APPLICATION NOTE 221

DS276x Product Comparison

Abstract: This application note describes the differences between the DS2760 battery monitor and protector and the DS2761 battery monitor and protector. It describes each difference in detail and indicates what, if any, changes would be required to an existing design to switch between the DS2760 and its predecessor, the DS2761.

Figure 1.

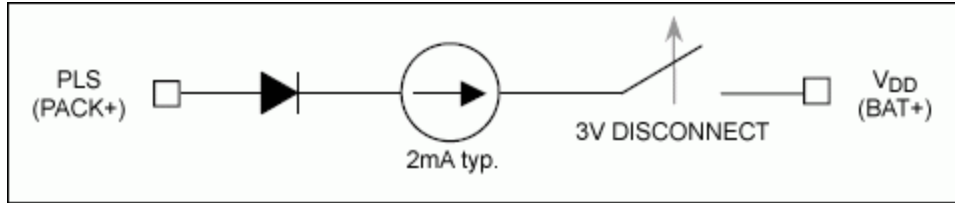
The DS2760C2, DS2761, and DS2762 provide a maximum 10mA (2mA typical) charge path from the PLS pin to the VDD pin. A depleted cell can be charged through this path to a point sufficient to power the chip and allow normal charge. This path operates in parallel with any external charge path and otherwise does not affect normal operation of the IC. The cell cannot be discharged through the recovery path by pulling PLS low. Low-voltage recovery is disabled above 3.0V to prevent cell overcharge.

Figure 2.

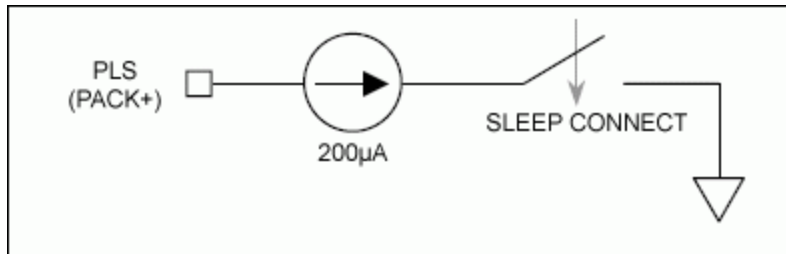
The DS2761 and DS2762 provide a 200µA pulldown on the PLS pin while in sleep mode. This new feature is only present while the chip is in sleep mode and prevents PACK+ from floating and possibly generating a false charger detection by the IC. It does not require any system or software changes if upgrading from the DS2760.
